PARTIAL LEVEL-08 NEW STEEL COLUMN ADHESIVE ANCHOR PLAN-(PHASE-1) (SEQ#-1)

PROJECT OWNER : 1250 MARYLAND AVENUE
PROJECT DESCRIPTION : 1250 MARYLAND AVENUE
PROJECT ADDRESS : 12
CONTRACTOR : BALFO
DRAWN BY : JSV
CHECKED BY : MNK
DWG DESCRIPTION : PA ANCHOR PLAN (PHASE-1)(SEQ#-2)

SK#05
06 pages
Date: 05-07-2025

1250 Maryland Avenue
1250 MARYLAND AVENUE SW
WASHINGTON, DC 20024

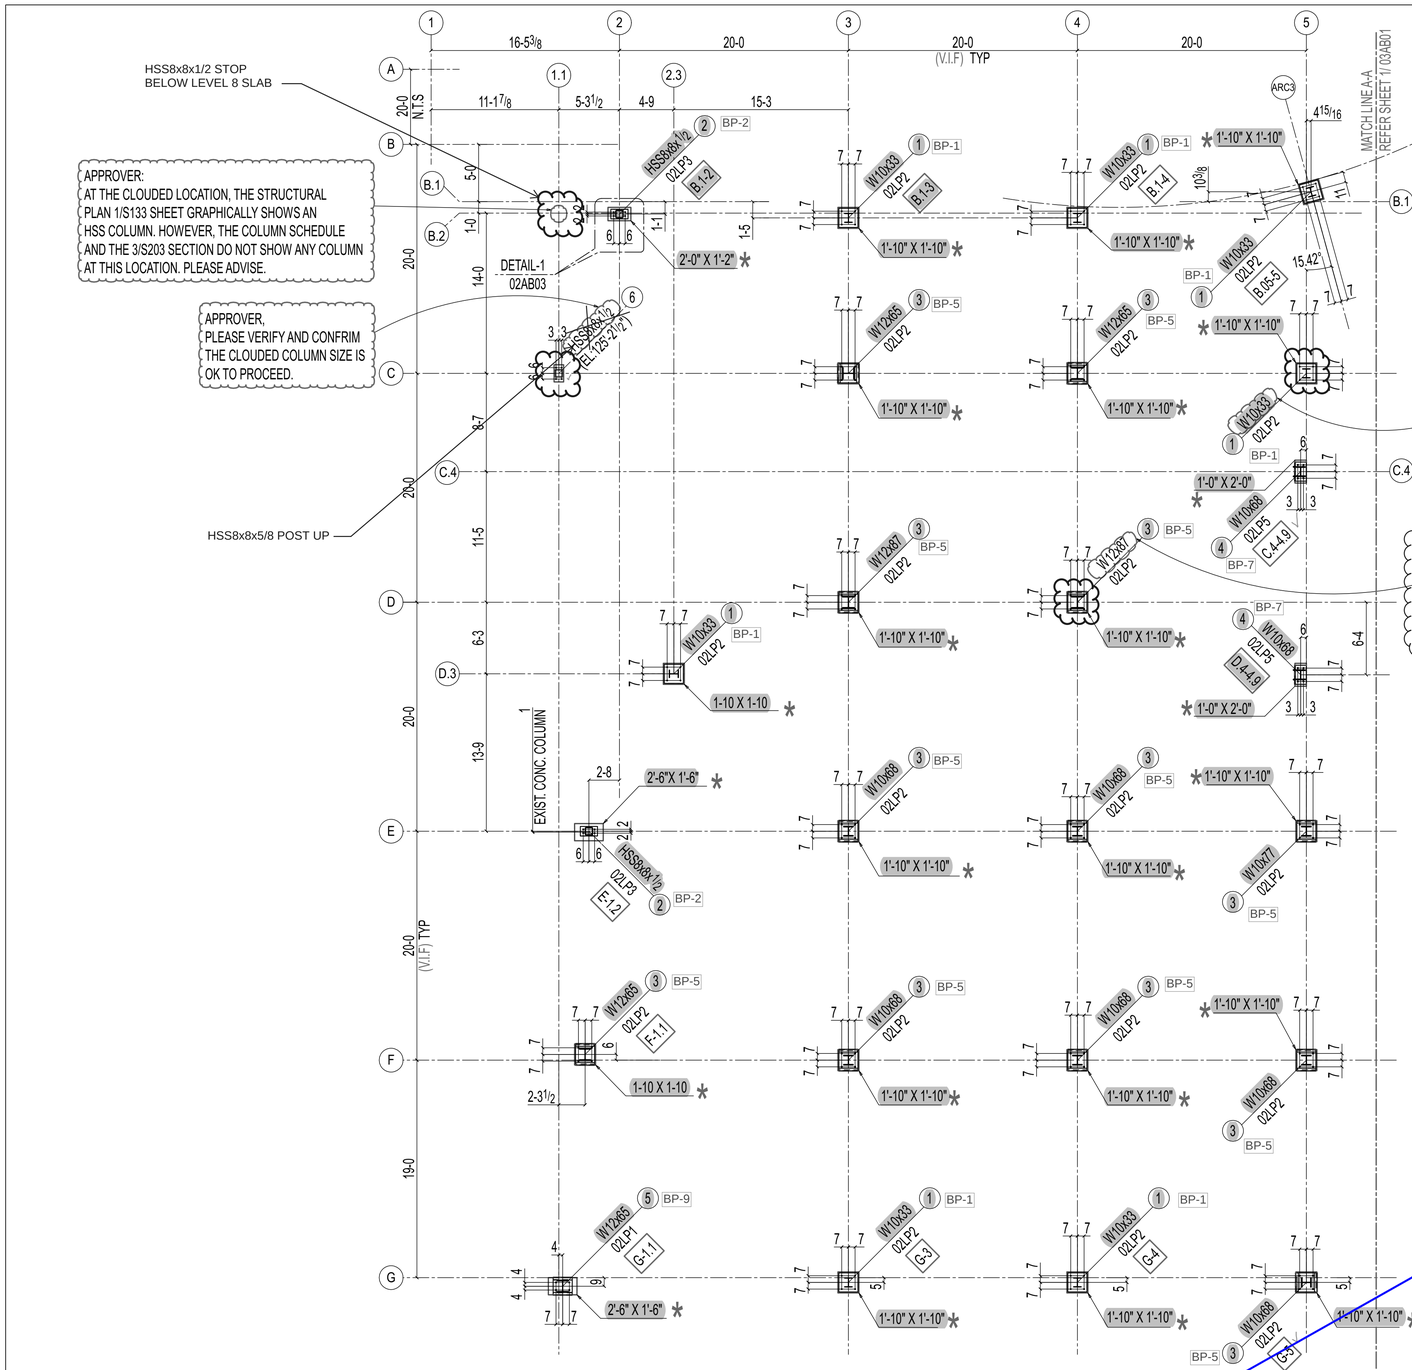
APPROVER, PLEASE VERIFY AND CONFIRM CLOUDED EXISTING LEVEL-08 SLAB ELEVATION.

PLEASE CENTER ALL NEW STEEL COLUMN WITH CENTER OF EXISTING CONCRETE COLUMN.

FOR LOCATIONS WHERE CENTERINING IS NOT POSSIBLE, PROVIDE DETAIL LOCATION INFORMATION FOR REVIEW

ARCH. PLEASE COMMENTS

APPROVER, PLEASE REVIEW AND VERIFY ALL EXISTING COLUMN SIZES ARE OK TO PROCEED?

APPROVER; STRUCTURAL DRWAINGS DO NOT SHOW PREVIOUS GRID DIMENSIONS FOR THE ARC WHICH WE HAVE FOLLOWED. HOWEVER WE HAVE RECEIVED FIELD MEASUREMENT FOR THE CENTER OF EXISTING COLUMN.

AFTER INCORPORTAING THE ALL FIELD MEASUREMENT, WE HAVE PLACE MOST OF THE NEW COLUMNS AT CENTER OF EXISTING CONCRETE COLUMNS.

ADDITIONALLY,WE HAVE OFFSETTED THE SOME COLUMN FROM CENTER OF EXISTING CONCRETE COLUMN SINCE STRUCTURAL DRAWING GRAPHICALLY SHOWNS THE NEW COLUMN FROM EX.CONCRETE COLUMN CENTER PLEASE ADVISE TYPICAL FOR THIS PROJECT.

SLAB ELEVATION IS AN EXISTING CONDITION THAT SHOULD BE VERIFIED IN FIELD.

ALL COLUMNS TO BE CENTERED ON EXG COLUMNS UNLESS NOTED OTHERWISE.

RESPONSIBILITY OF CONTRACTOR AND GC TO VERIFY ALL EXISTING CONDITIONS, REVIEWED TO CONFIRM WITH DESIGN DRAWINGS ONLY

EXISTING COLUMN SIZES CONFIRMED WITH EXISTING STRUCTURAL DRAWINGS. VERIFY IN FIELD FOR ACTUAL COLUMN SIZE

SEE NOTE 8 ON S133 "ALL GRID DIMENSIONS TO BE VERIFIED IN FIELD"

3 COLUMN BASE DETAIL - EXISTING PIER
SCALE: 3/4" = 1'-0"

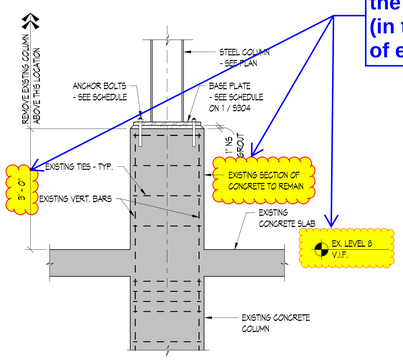
Q2

Please field verify and confirm that the ALL existing concrete columns (in this project)height is 3-0 from top of existing slab at level-8.

1 PARTIAL LEVEL 08 FRAMING PLAN - ZONE D
SCALE: 3/16" = 1'-0"

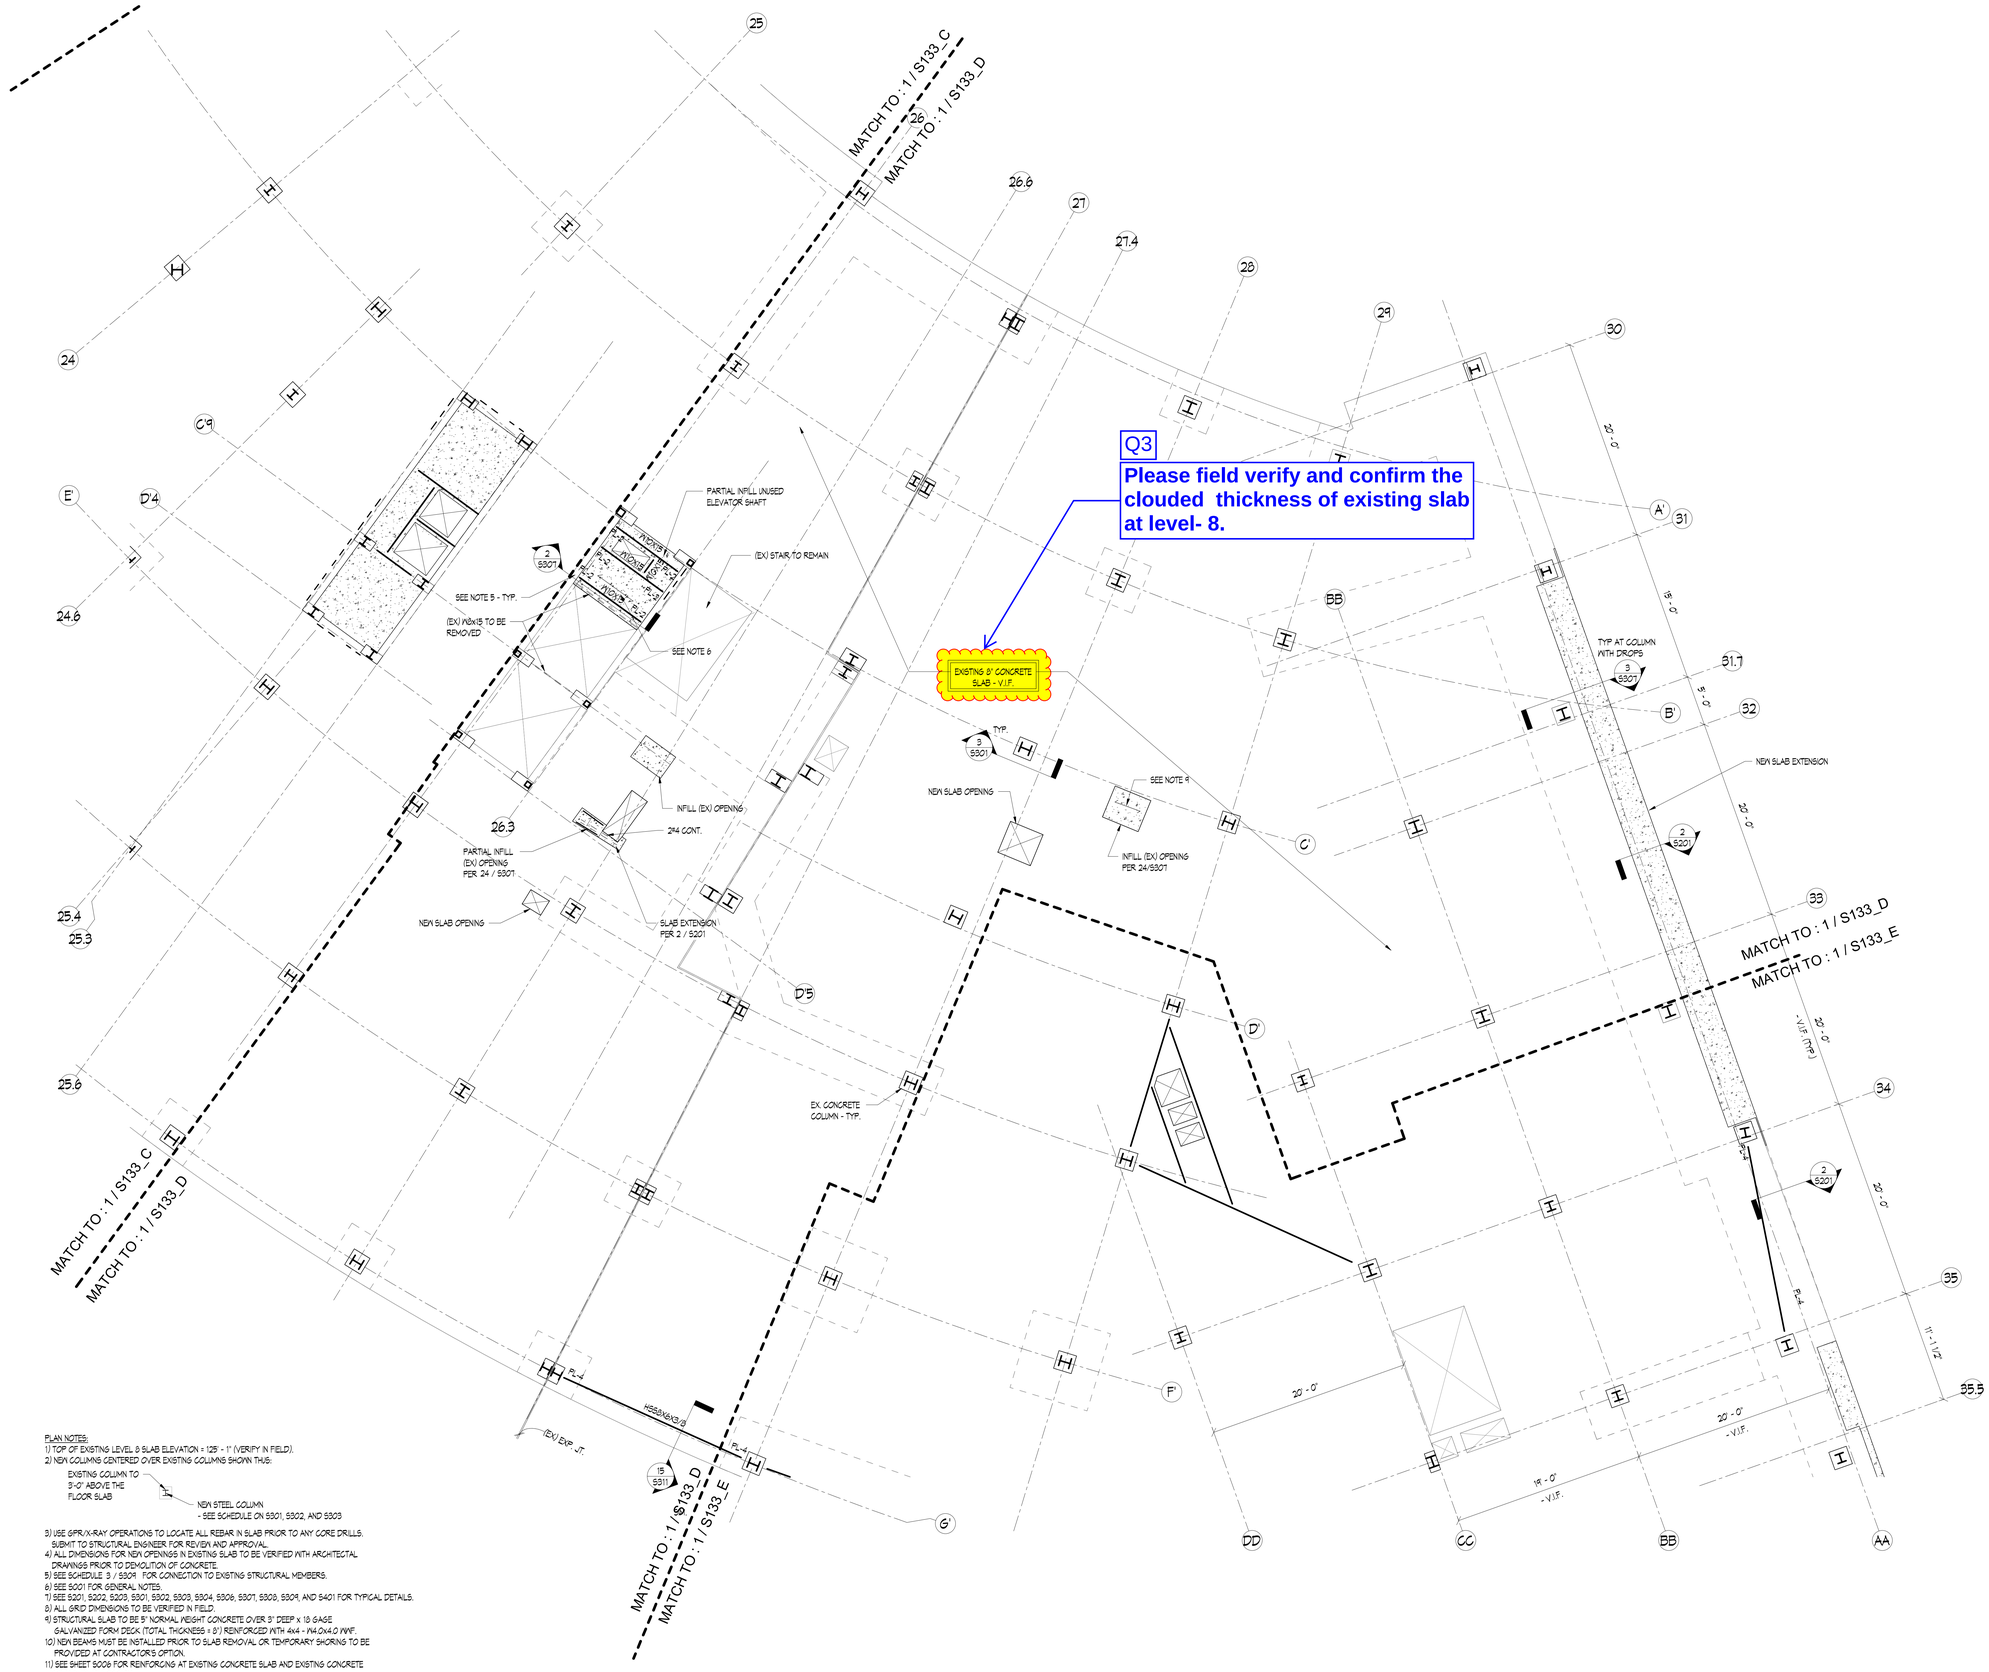
Q1

Please field verify and confirm the clouded top of existing slab elevation at 8th level.

Q4

Please field verify and confirm if the green clouded existing concrete column skew/orientation is parallel to grid 23.

Q5

Please field verify and confirm if the orange clouded existing concrete column skew/ orientation is parallel to grid 24.

Q6

Please field verify and confirm if these brown clouded existing concrete columns skew/orientation are parallel to grid 26.

Q7

Please field verify and confirm if the magenta clouded 6-existing concrete columns skew/orientation are parallel to grid 26.6.

Q8

Please field verify and confirm if these purple clouded existing concrete columns skew/orientation are parallel to grid 28.

Q9

Please field verify and confirm if these cyan clouded existing concrete columns skew/orientation are parallel to grid 27.4.

2 A056 SLAB EDGE - LEVEL 08
1" = 20'-0"

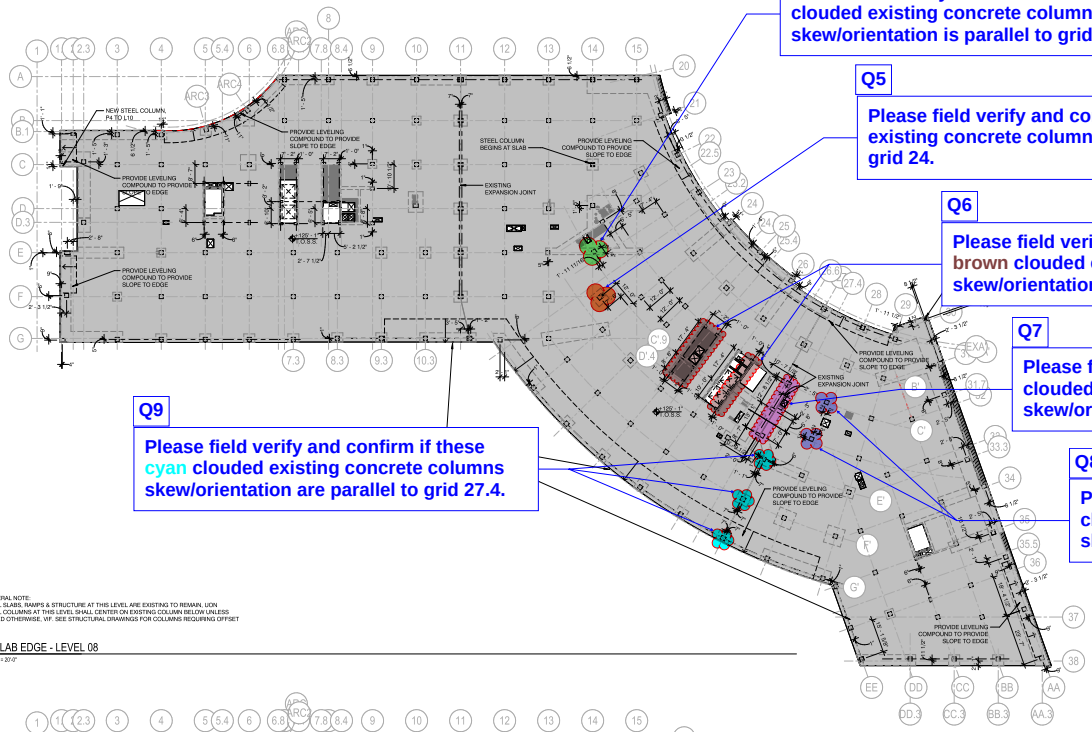
Q10

At the clouded location, please provide existing concrete column size at below level-8 slab.

2 A056 SLAB EDGE - LEVEL 08
1" = 20'-0"

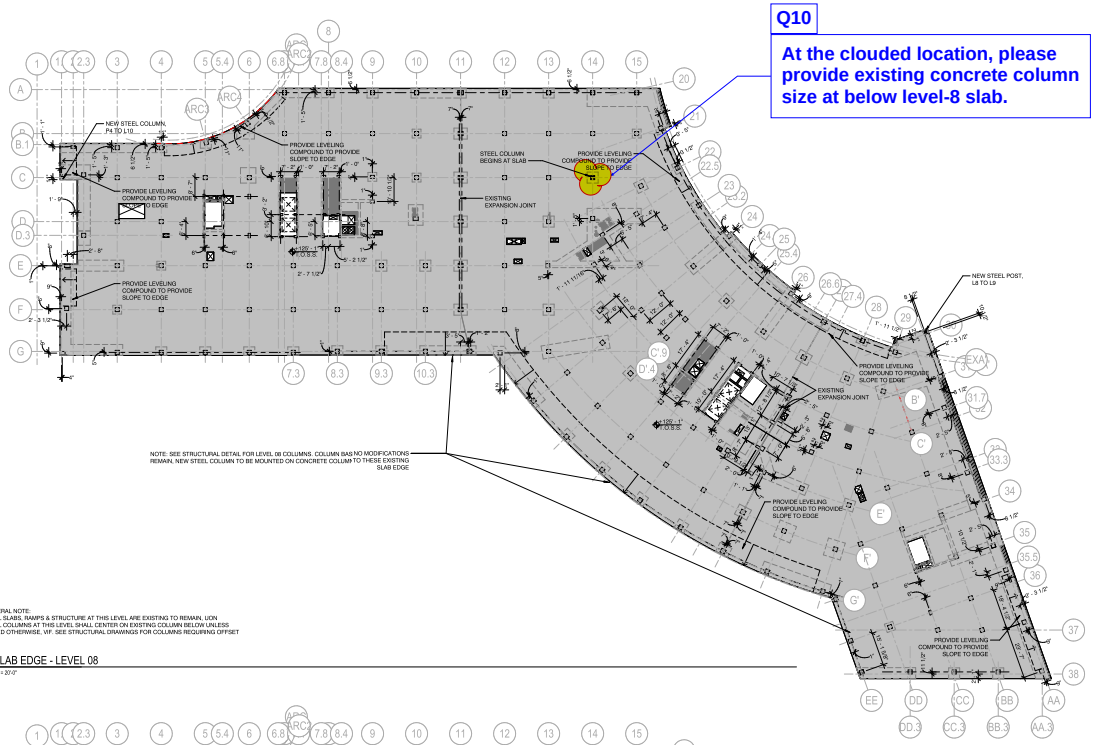
Q11

Please field measure and provide all yellow clouded ?? dimensions for center of existing concrete column to grid.
